APPENDIX J AVIATION ADVICE LETTER

Re: Hills of Gold Wind Farm – AIA Addendum

This letter of advice will provide an addendum to the Aviation Impact Assessment to be attached to the client's Amendment Report 2.

Turbine Layout Amendments

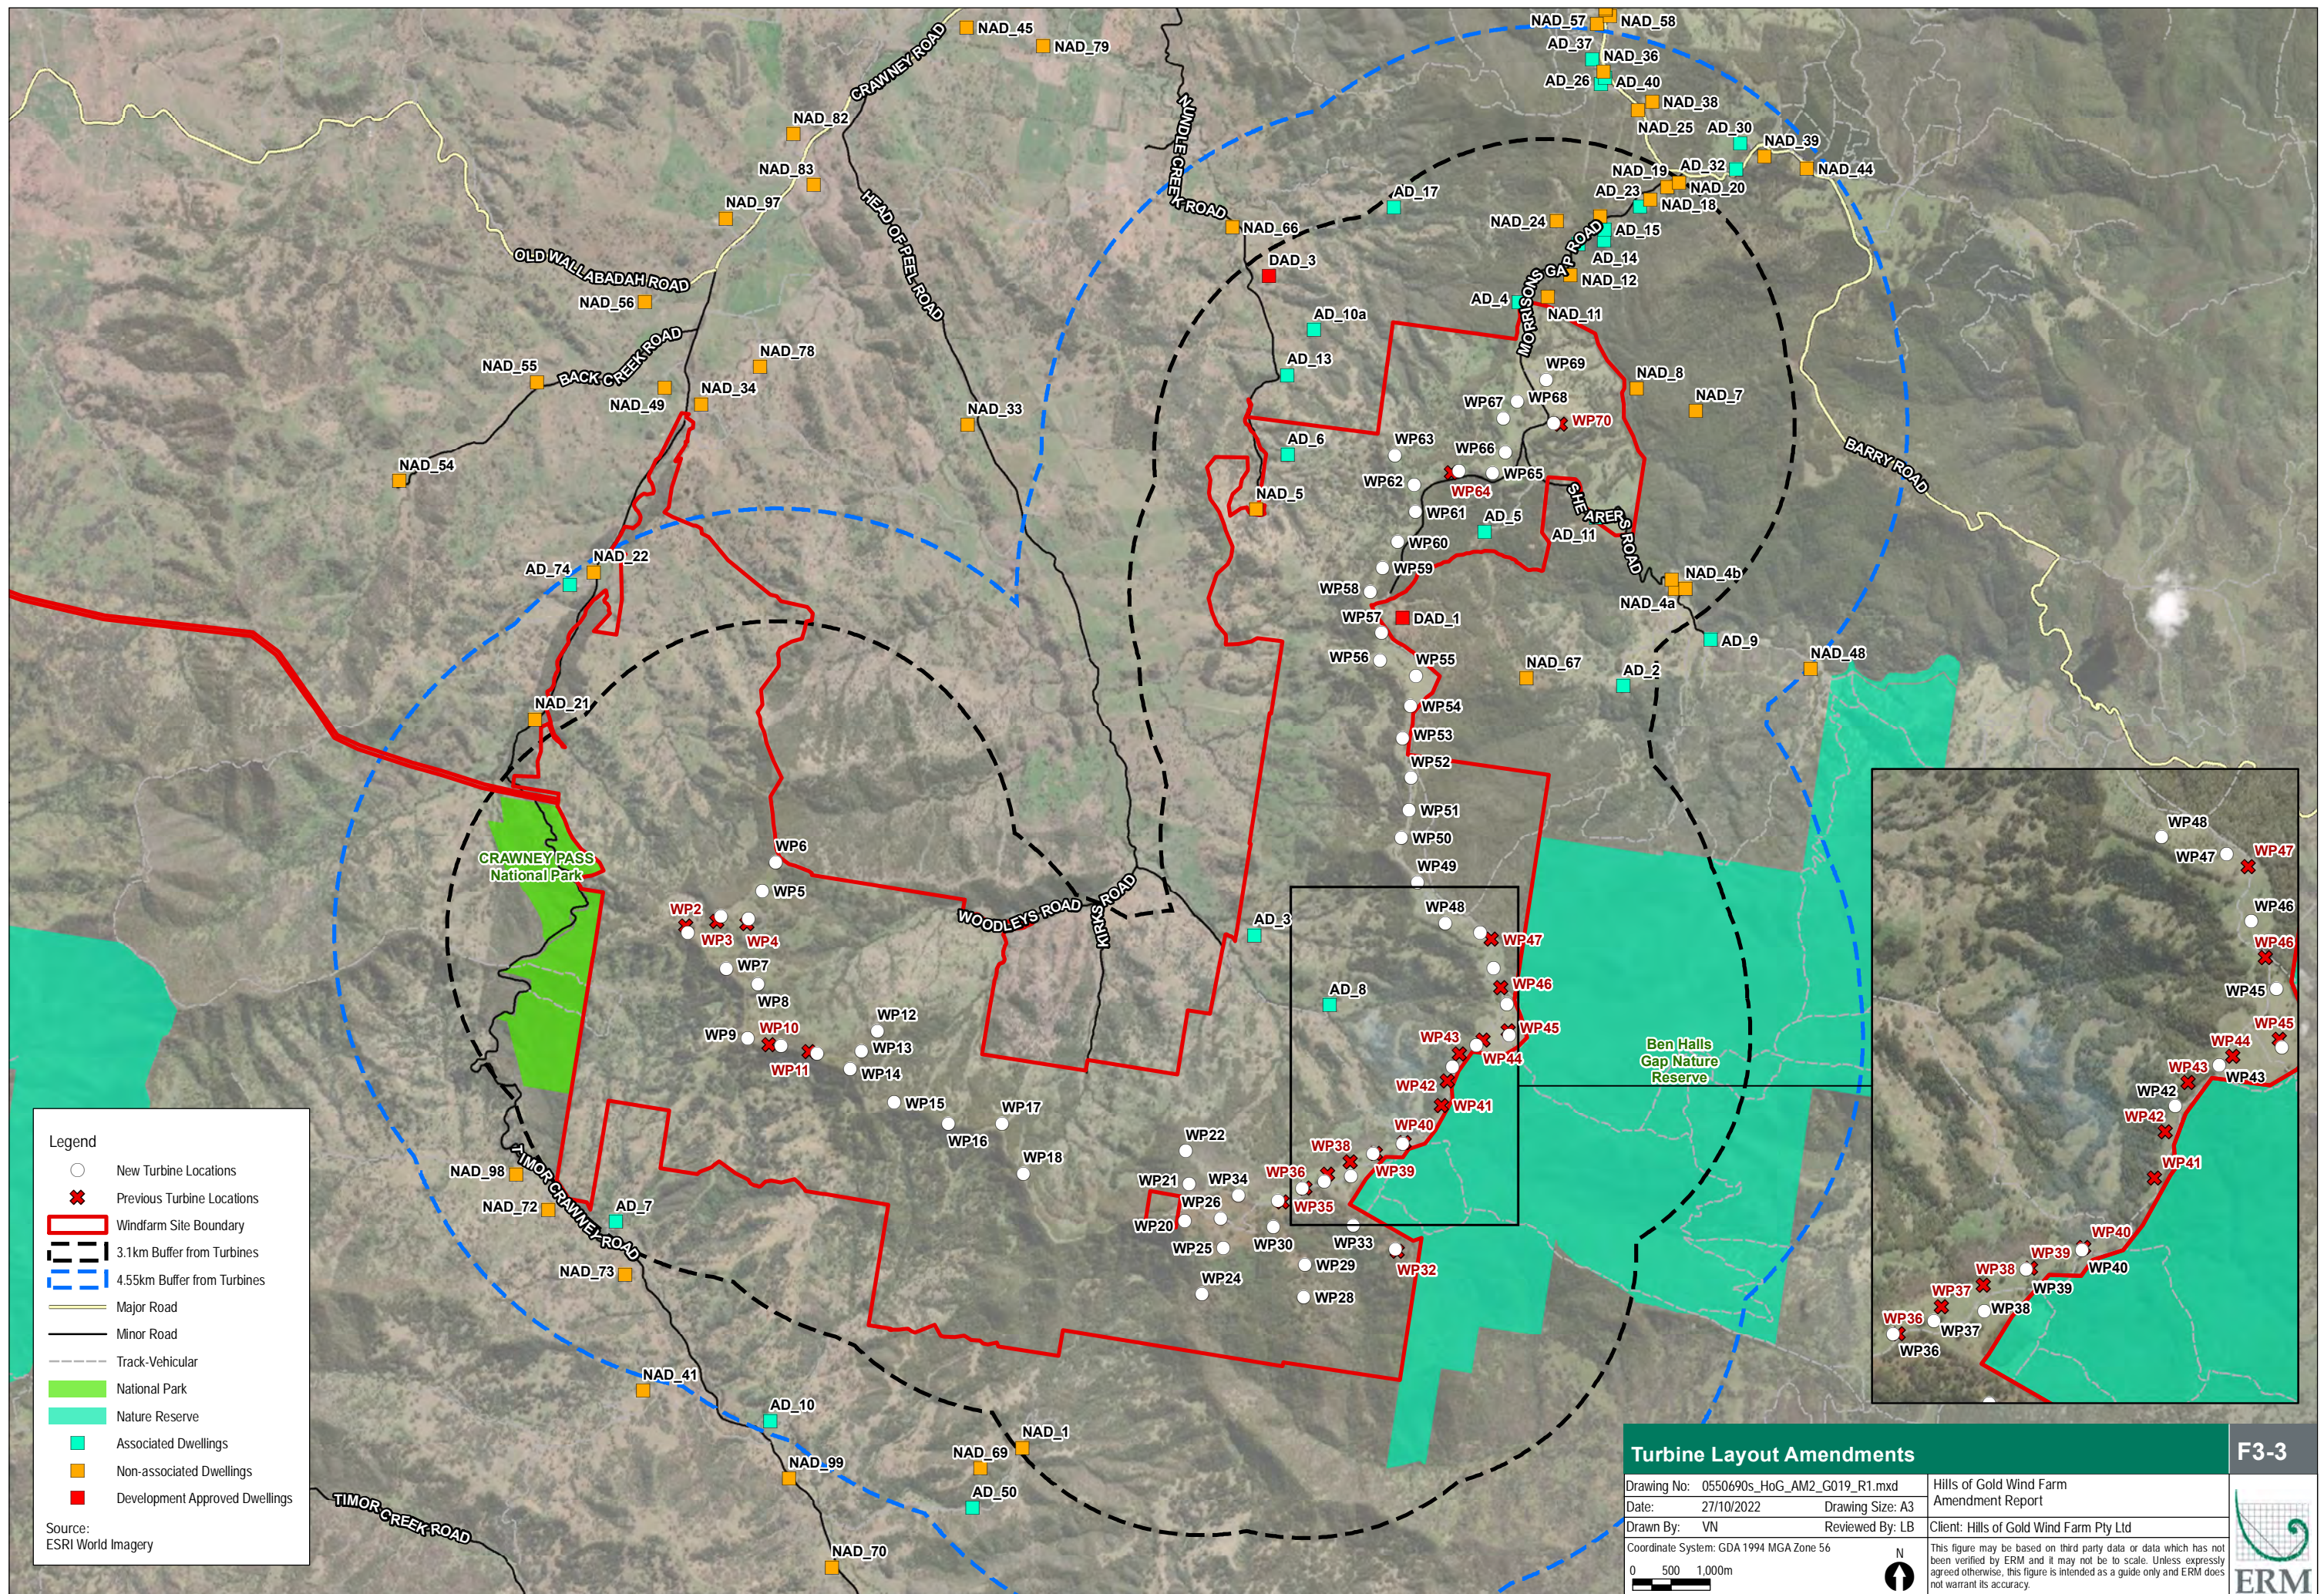
- WTG 41 is proposed to be removed to create a 1.2 km buffer along Ben Halls Gap Nature Reserve that will:
 - Reduce bird and bat barrier effects; and
 - Reduce NPWS aerial firefighting concerns.
- 10 turbines (WTGs 2, 3, 4, 32, 35, 36, 39, 40, 64, 70) are to be relocated within 100 m of the previous location; and
- 10 turbines (WTGs 10, 11, 37, 38, 42, 43, 44, 45, 46, 47) are to be relocated within 350 m of the previous location.

The revised WTG layout is shown in ERM drawing Turbine Layout Amendments attached at the end of this report.

Removal of WTG 41 and relocation of 20 WTGs listed in Table 1 will not alter the conclusions and recommendations of the original aviation impact assessment.

There are no changes to the impacts previously identified for obstacle limitation surfaces (OLS), flight procedure (PANS-OPS) surfaces, grid and air route lowest safe altitudes (LSALTS), prescribed airspace or aviation navigation aids and communication facilities.
